ADDENDUM NO. 18

**Westfield Washington School Corporation
Centennial Road Reconstruction
Bid Package 05
17707 Centennial Road,
Westfield, IN. 46074**

ADDENDUM

PROJECT: Westfield Middle School – West

WESTFIELD WASHINGTON SCHOOLS
TYPICAL SECTIONS

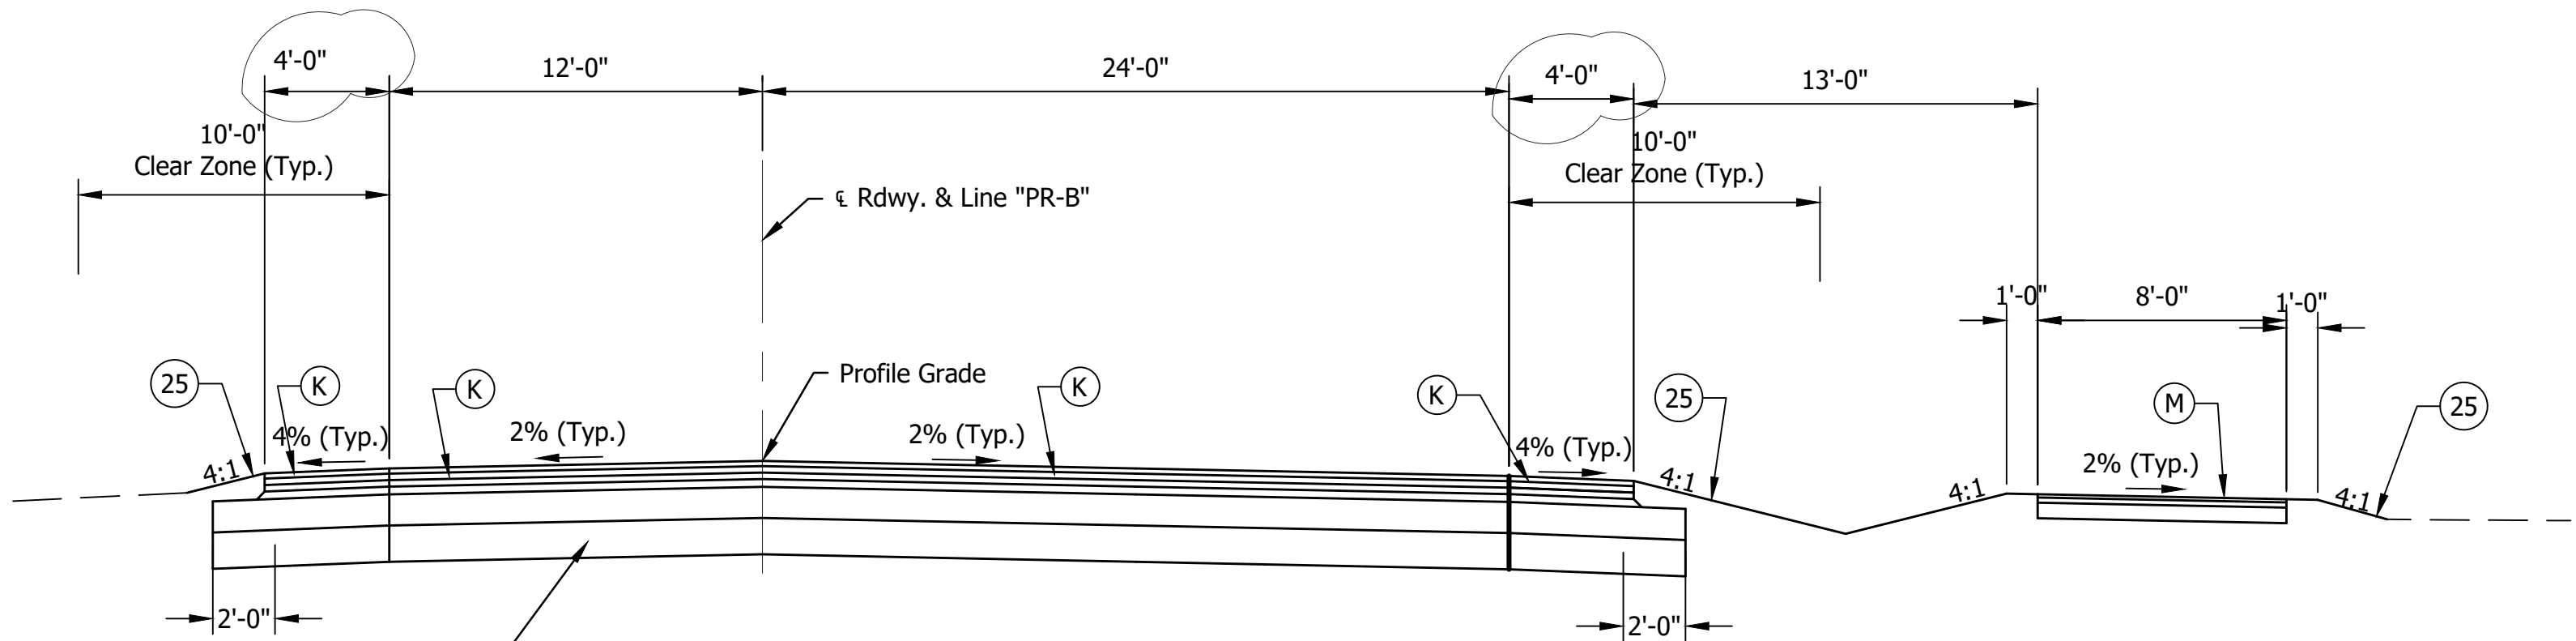
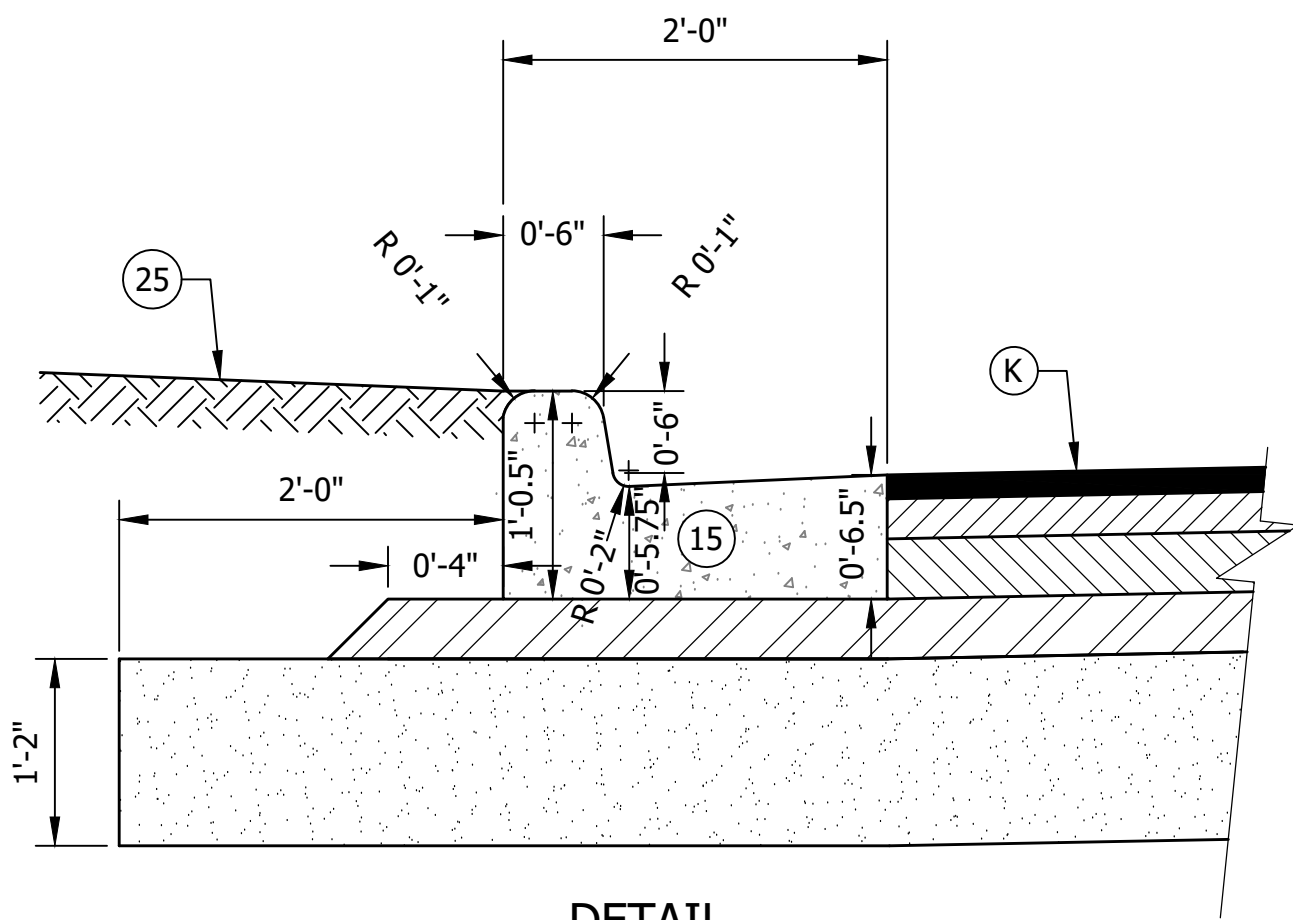
4.2 SHEET 3 – TYPICAL SECTIONS

- A. Updated shoulder width, Updated legend

REVISIONS	
DATE	ITEM
Oct 2, 2025	Updated shoulder width Removed Sodding from Legend

PLAN - LINE "PR-B"
STA. 10+00.00 TO STA. 16+00.00

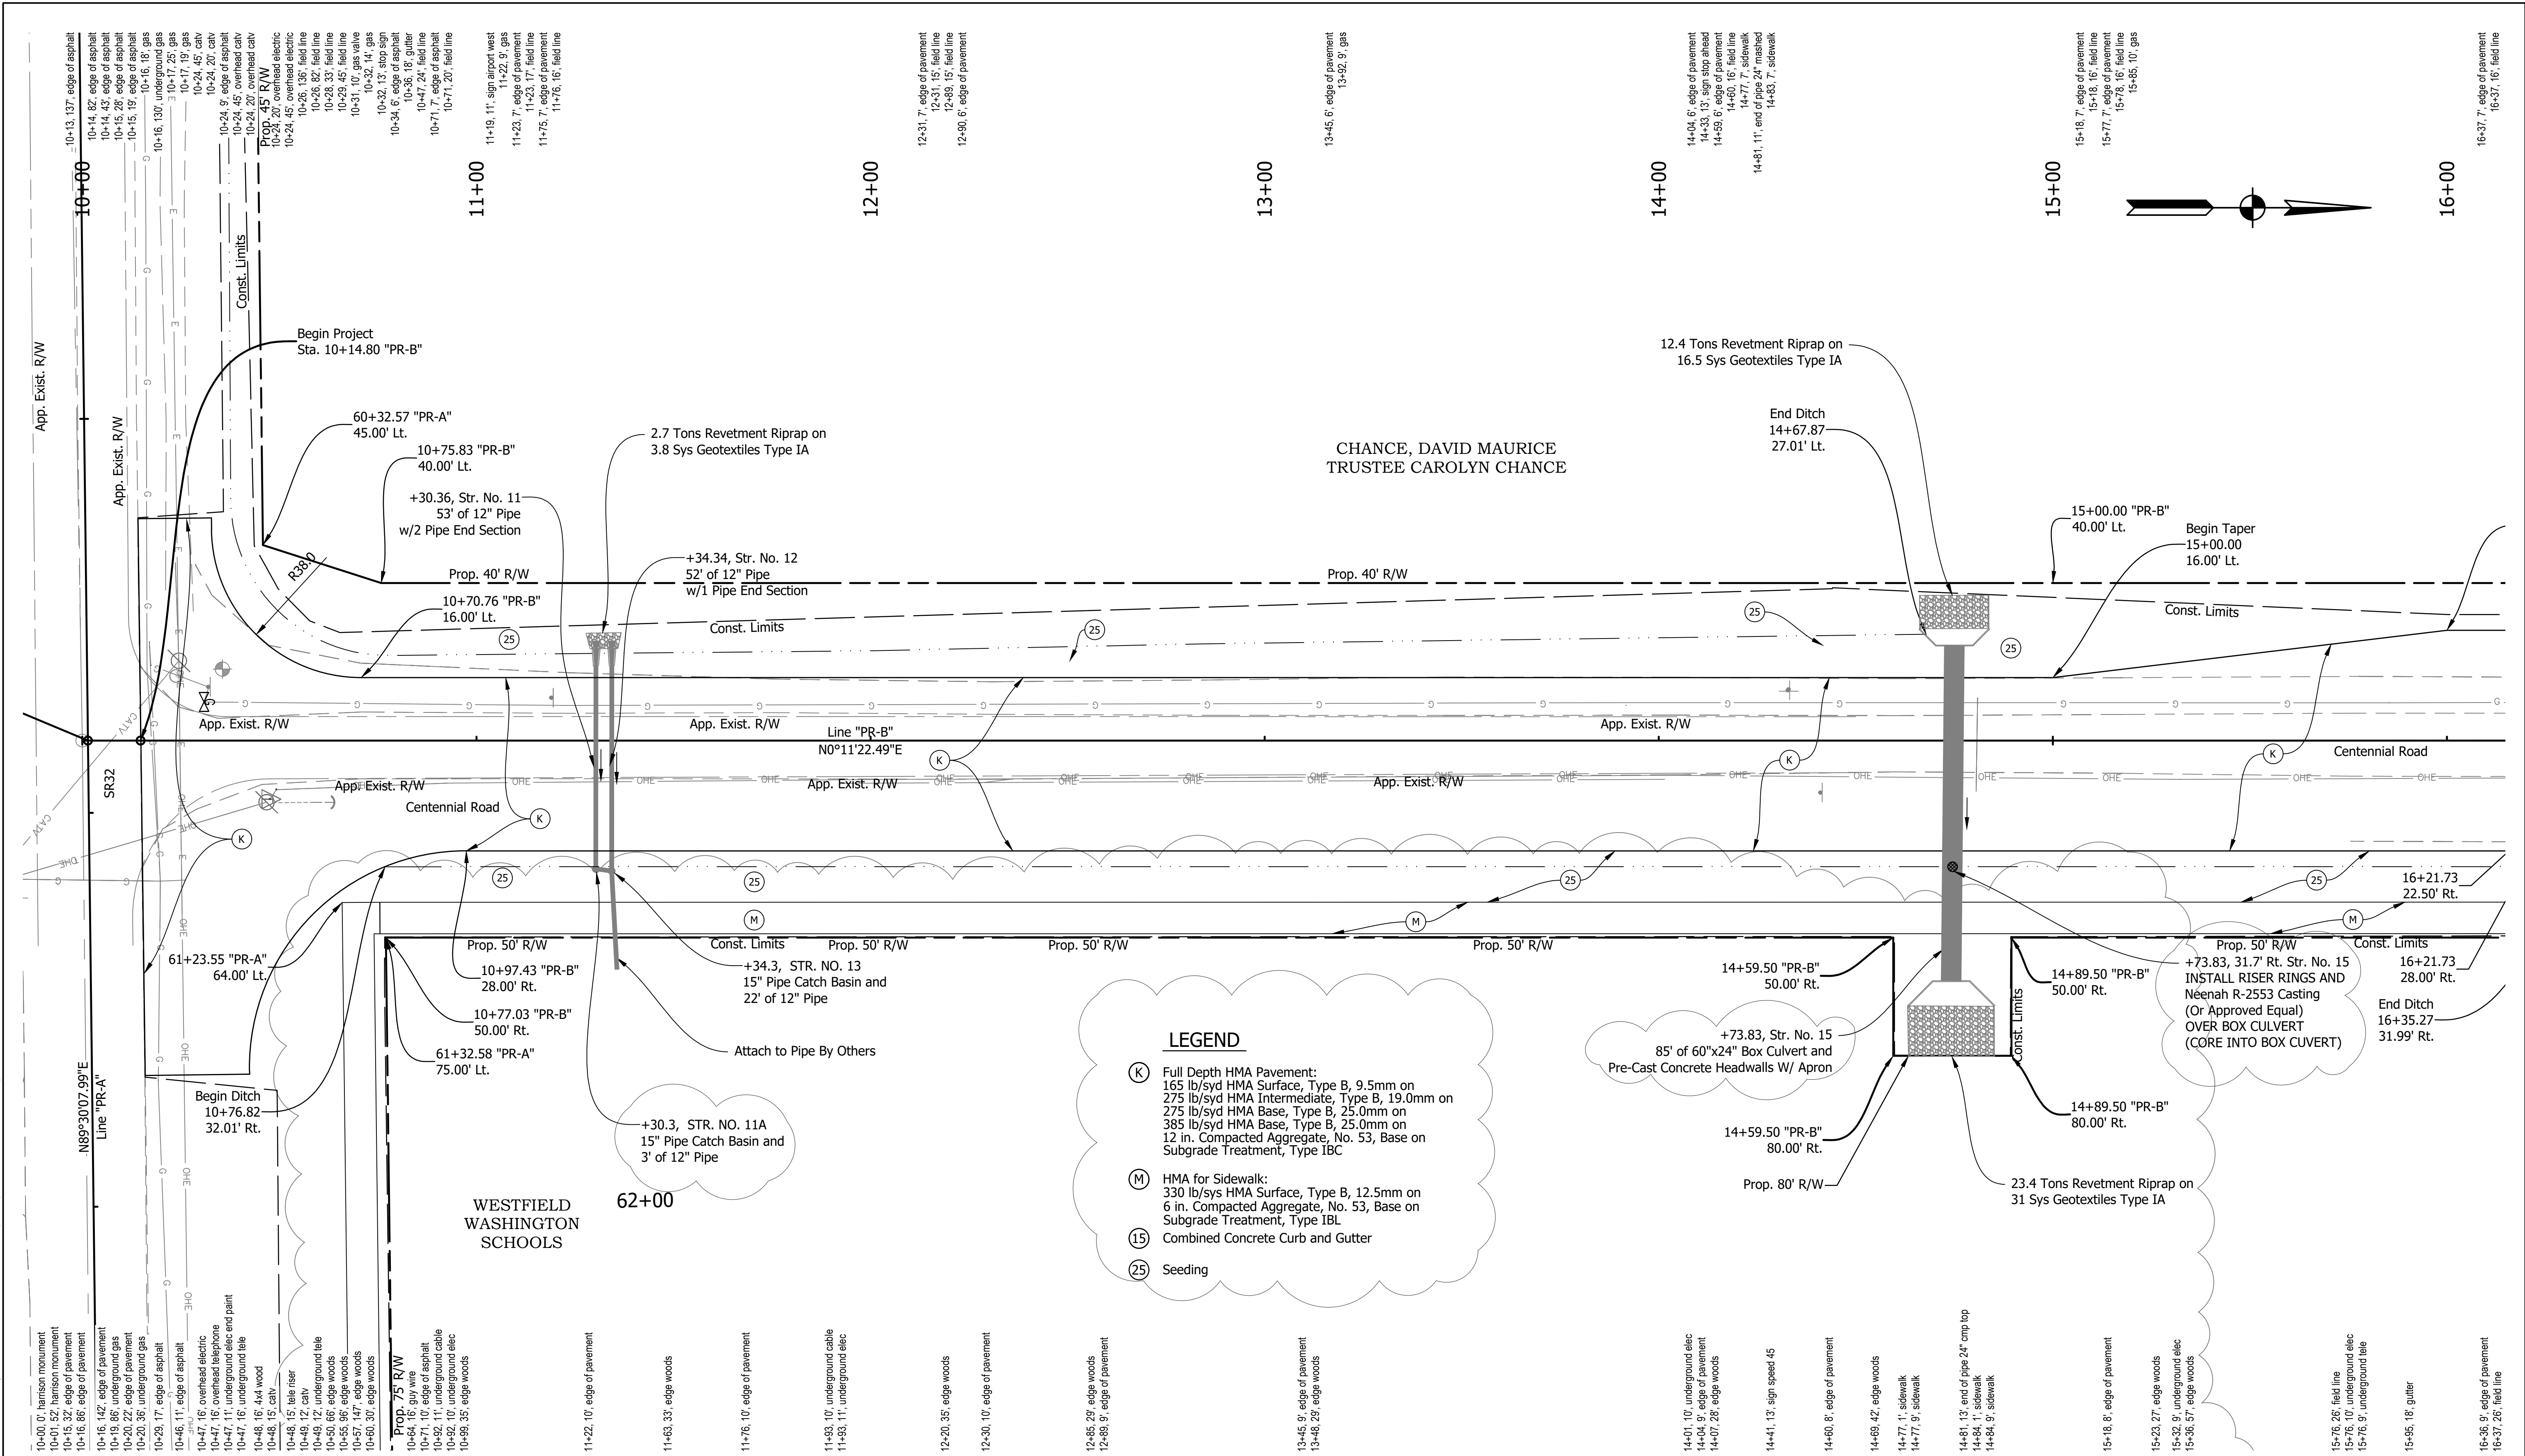
4.3 SHEET 10 - PLAN - LINE "PR-B" STA. 10+00.00 TO STA. 16+00.00

- A. Updated Str. 11A, Added detail notes to box culvert and casting

REVISIONS	
DATE	ITEM
Oct 2, 2025	Updated Str. 11A, Added detail notes to box culvert and casting
	Updated Legend

WESTFIELD WASHINGTON SCHOOLS
PLAN - LINE "PR-B" 16+00.00 to 22+00.00

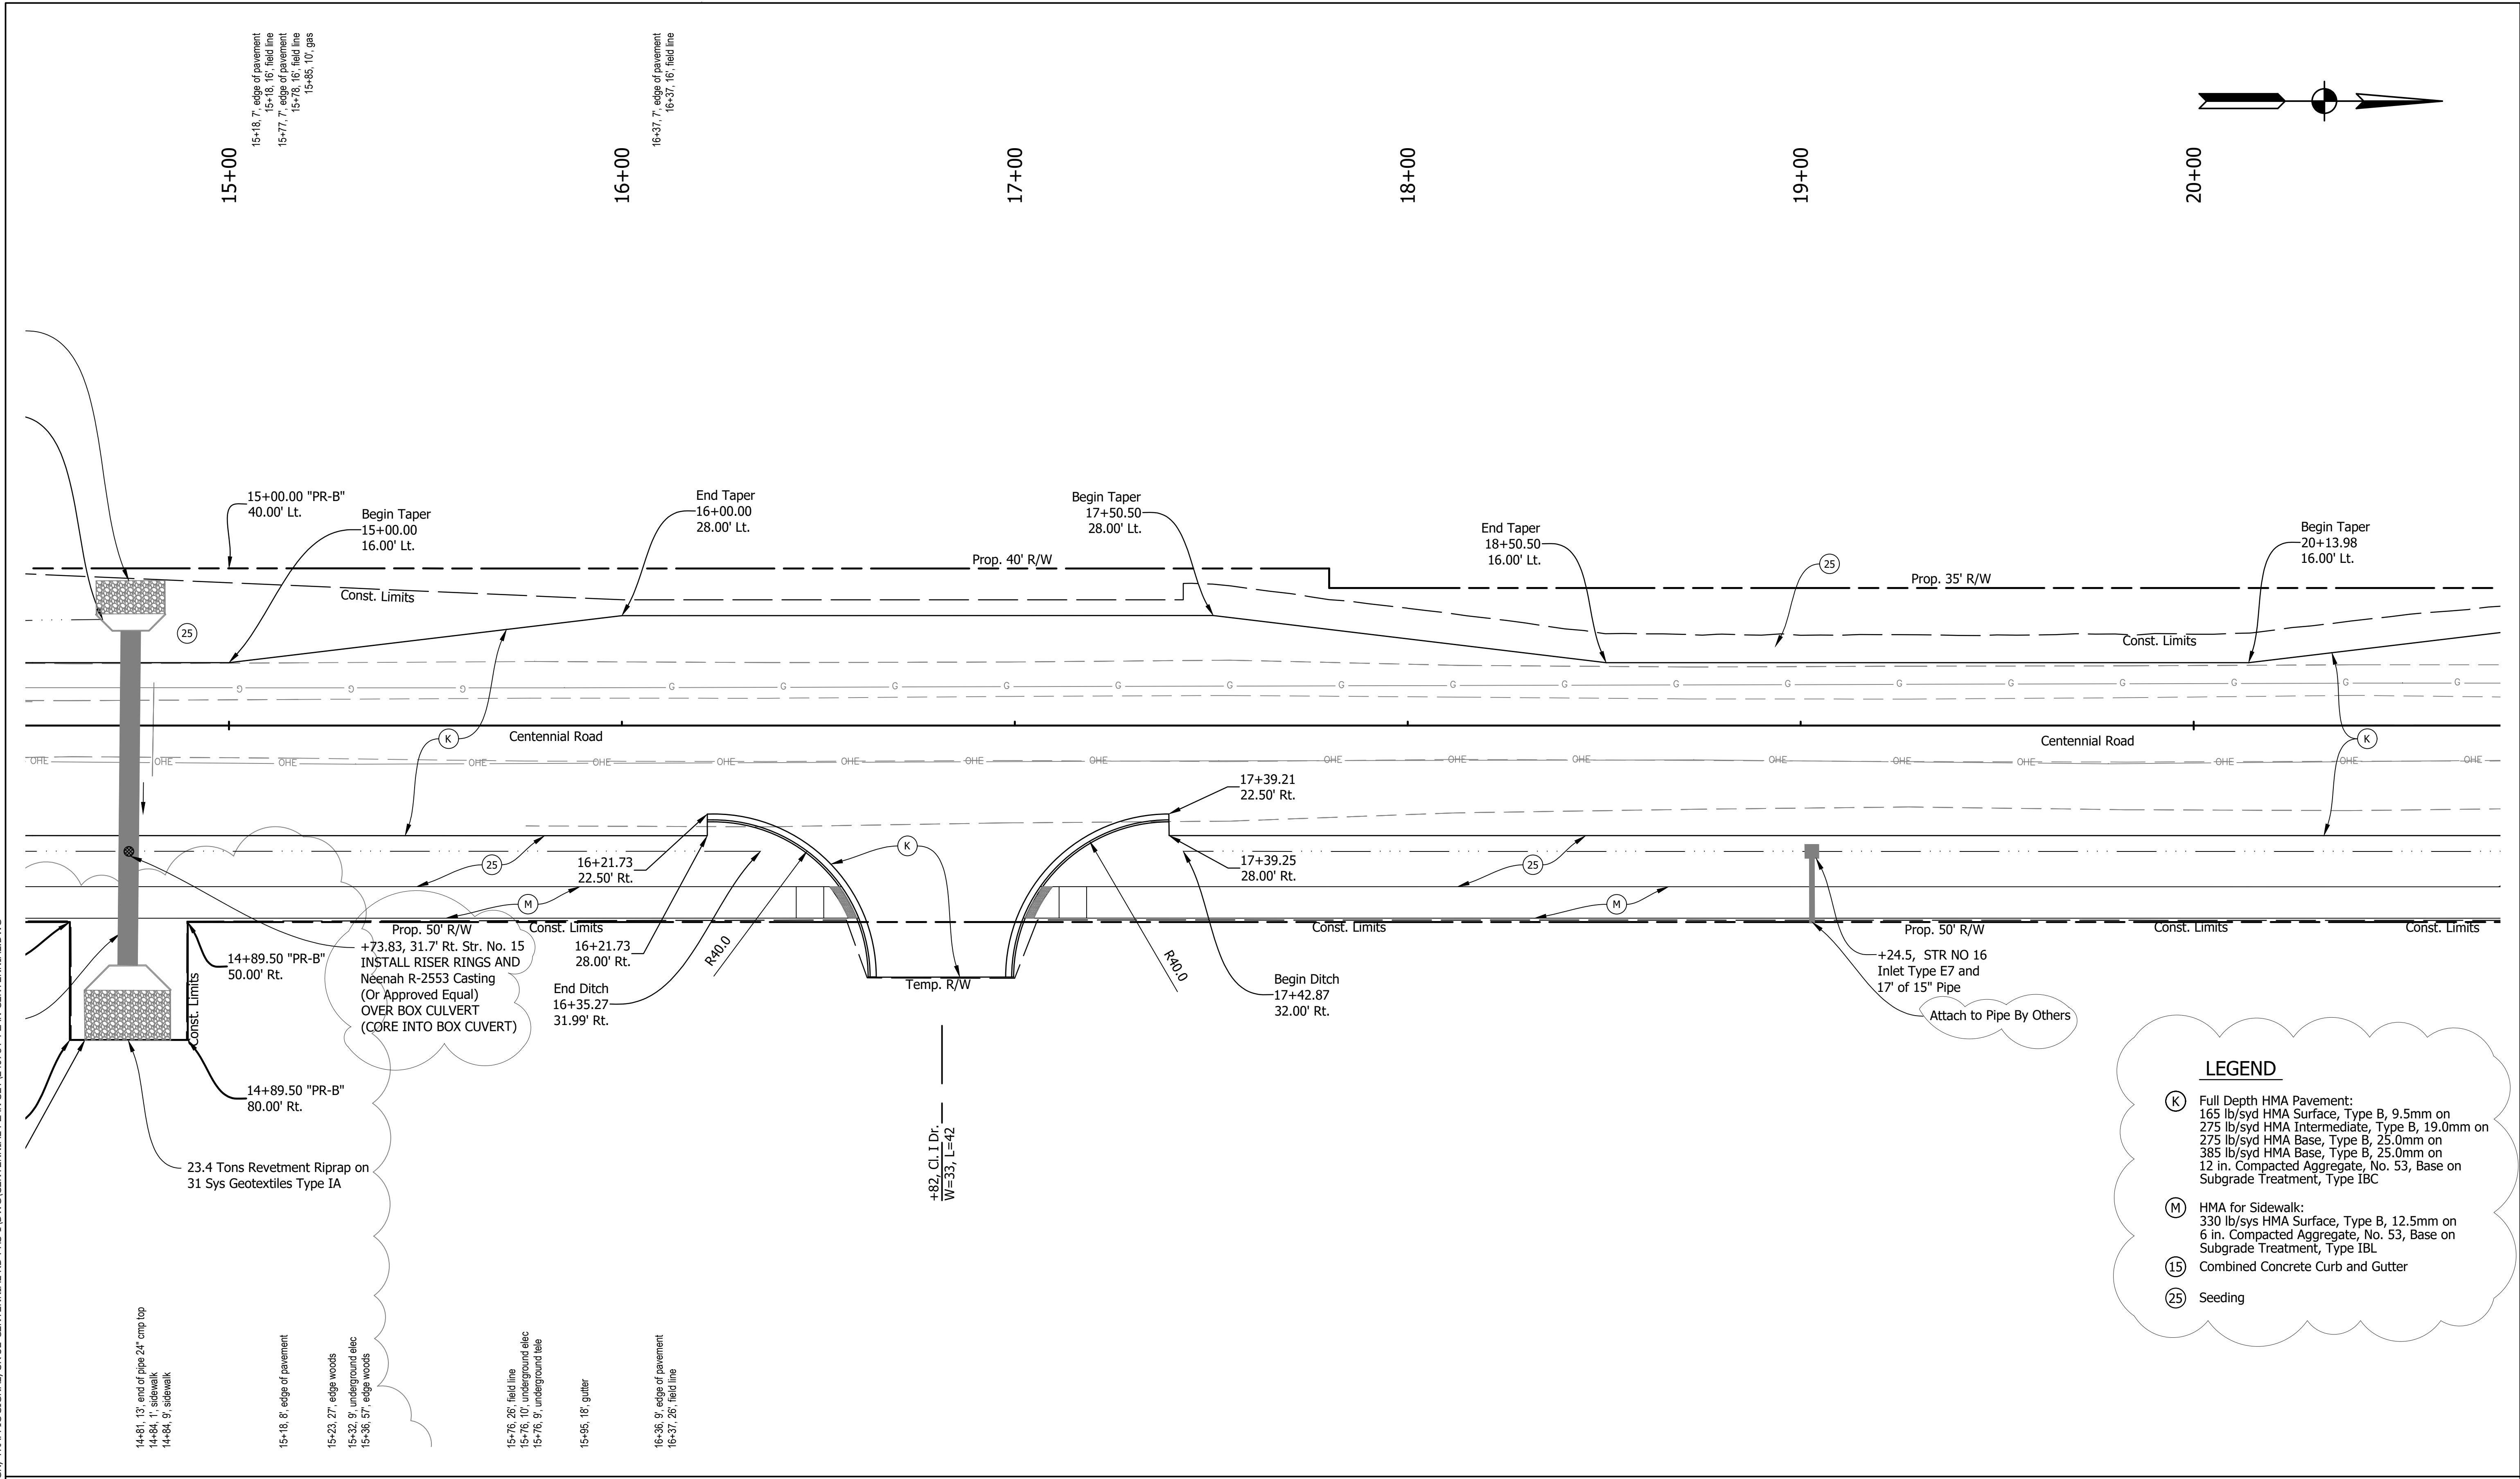
4.4 SHEET 12 - PLAN - LINE "PR-B" 16+00.00 to 22+00.00

- A. Added "Attach to Pipe By Others" note to Str. 16, Removed extra pavement line, updated legend

REVISIONS	
DATE	ITEM
Oct 2, 2025	Added detail notes to box culvert and casting
	Added "Attach to Pipe By Others Note"
	Updated Legend
